**APPLICATION FOR PERMISSION
UNDER SECTION 16 OF
THE TOWN PLANNING ORDINANCE
(CAP.131)**

For Official Use Only 請勿填寫此欄	Application No. 申請編號	A17L-LFS/431
	Date Received 收到日期	30 JUN 2022

Proposed Temporary Public Vehicle Park for Private Cars and Light Goods Vehicles for a Period of 3 Years
at
Lots 2522 RP (Part), 2526 and 2922 (Part) in D.D. 129, San Hing Tsuen, Yuen Long, N.T.

Proposed Drainage Plan

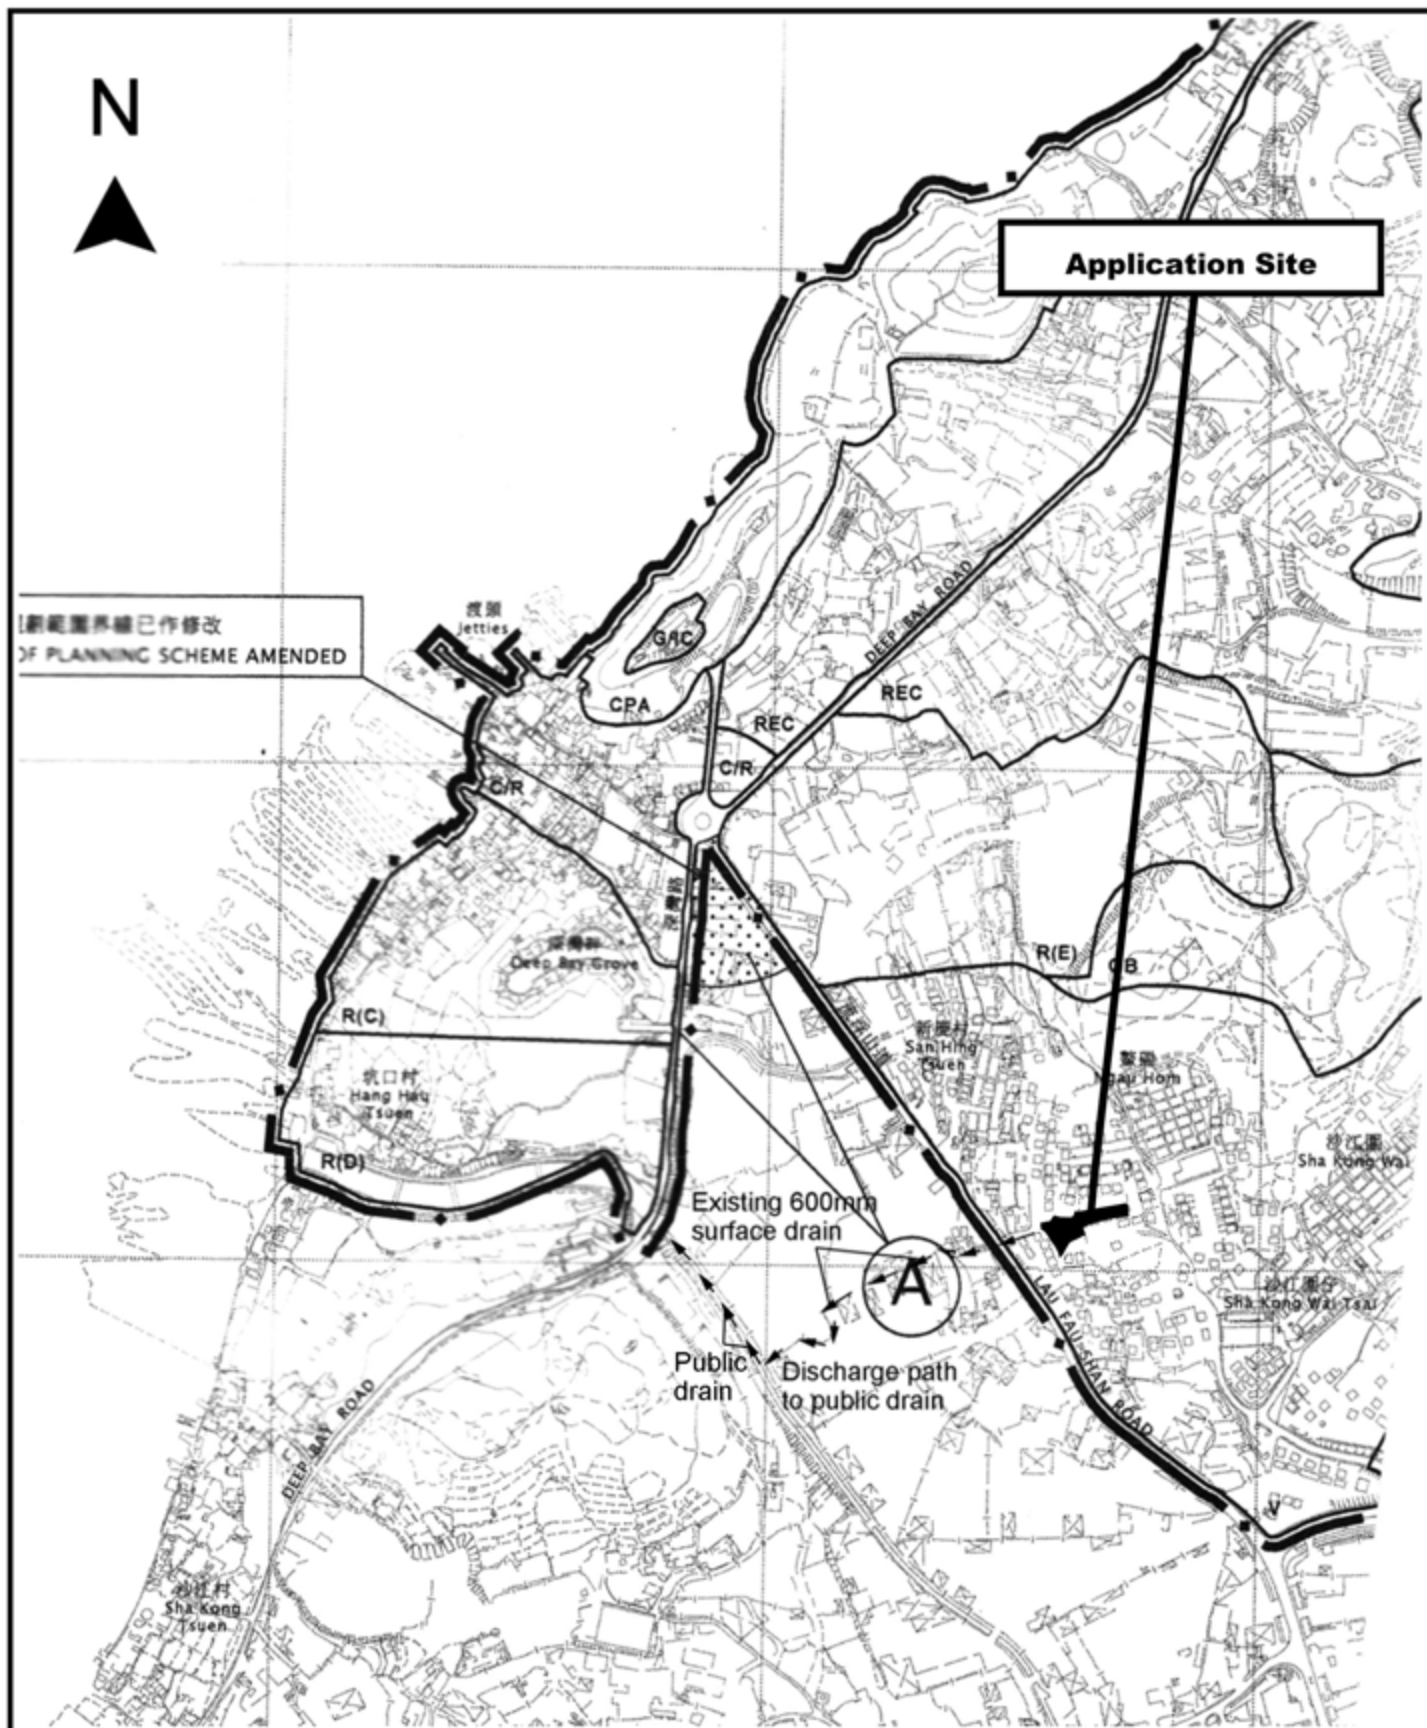
- (iii) further to (ii) above, since there is no record of the said discharge path, please provide site photos to demonstrate its presence and existing condition;

- (iv) the cover levels and invert levels of the proposed U-channels, catchpits/sand traps should be shown on the drainage plan;
 - (v) cross sections showing the existing and proposed ground levels of the Site with respect to the adjacent areas should be given;

- (a) He has no objection in principle to the application from drainage point of view.
- (b) Should the Board consider that the application is acceptable from planning point of view, a condition should be stipulated requiring the applicant to submit a revised drainage proposal, to implement and maintain the proposed drainage facilities to the satisfaction of his department.

Proposed Layout Plan

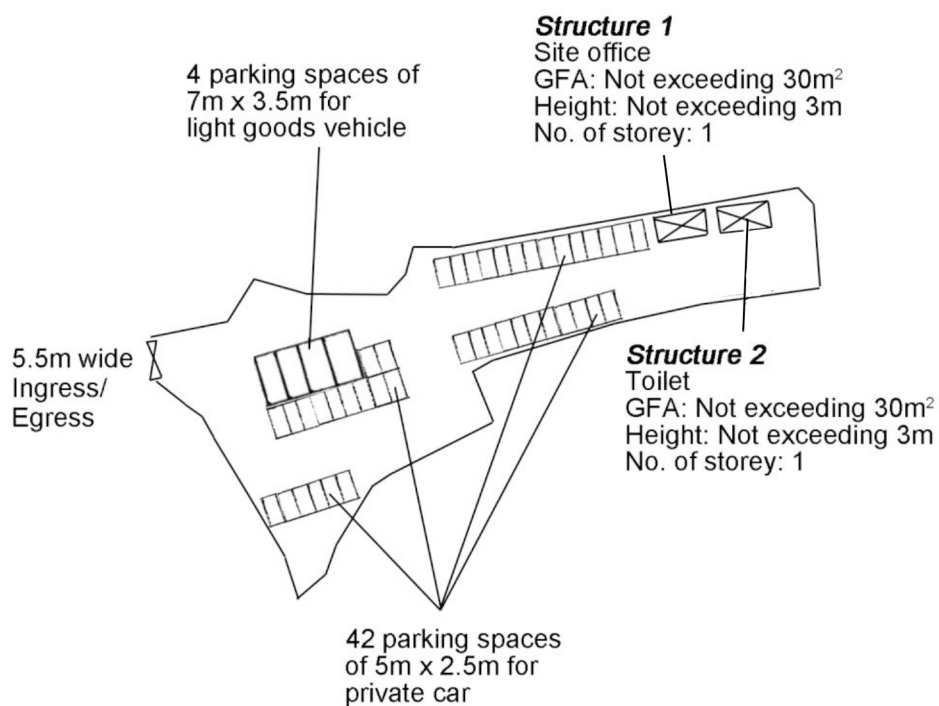
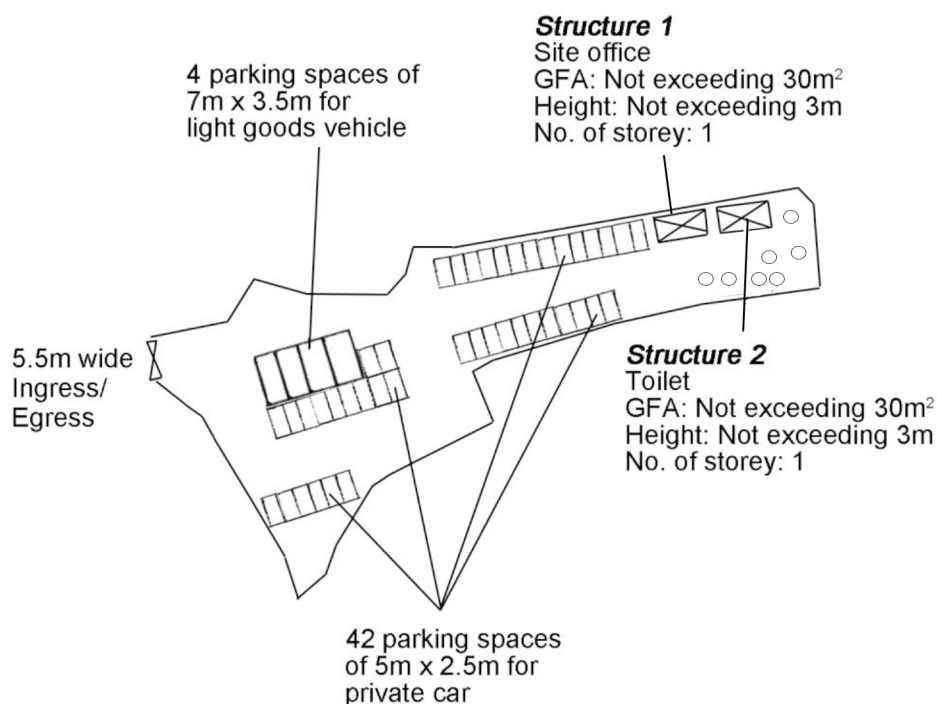
According to the Further Information submitted, the applicant confirmed that 7 existing trees at the eastern corner of the Site will be preserved. The proposed structure 2 (i.e. toilet) is also relocated to avoid tree felling. Further significant landscape impact on existing landscape resources within the Site is not anticipated. As such, she has no comment on the application from landscape planning perspective.

We are glad to submit the proposed landscape and tree preservation plan (Figure 7) herewith for the consideration of CTP/UD&L, Planning Department. In view of that all the existing trees will be preserved, the location of Structure 2 is relocated to avoid tree felling and it is shown in updated layout plan (Figure 3).
